Notification#20240628014.0
Device symbolization update for Select Devices
Information Only

Notification Number:	20240628014.0	Notification Date:	June 29, 2024		
Title:	Device symbolization update for select Devices				
Customer Contact:	Change Management team	Dept:	Quality Services		
Change Type:					
<input type="checkbox"/>	Assembly Site	<input type="checkbox"/>	Design	<input type="checkbox"/>	Wafer Bump Material
<input type="checkbox"/>	Assembly Process	<input type="checkbox"/>	Data Sheet	<input type="checkbox"/>	Wafer Bump Process
<input type="checkbox"/>	Assembly Materials	<input type="checkbox"/>	Part number change	<input type="checkbox"/>	Wafer Fab Site
<input type="checkbox"/>	Mechanical Specification	<input type="checkbox"/>	Test Site	<input type="checkbox"/>	Wafer Fab Materials
<input checked="" type="checkbox"/>	Packing/Shipping/Labeling	<input type="checkbox"/>	Test Process	<input type="checkbox"/>	Wafer Fab Process

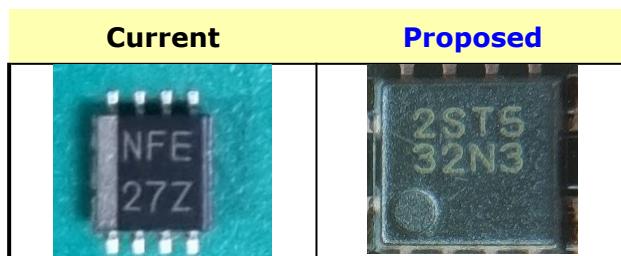
Texas Instruments Incorporated is announcing an update to the device symbolization for the devices shown below (pin one stripe to dot and 3 to 4 character) below as follows:
